T ECHNICAL INFORMATION

68498
(Page 1 of 3)

Subject ▶ Change of Blade Clamping System and Shoe

For Models ▶ JR3030T

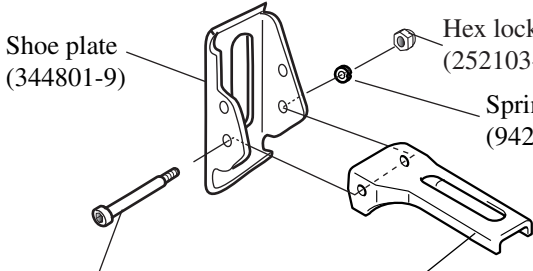
1) The following changes have been implemented to make the tool-less blade change system more durable.
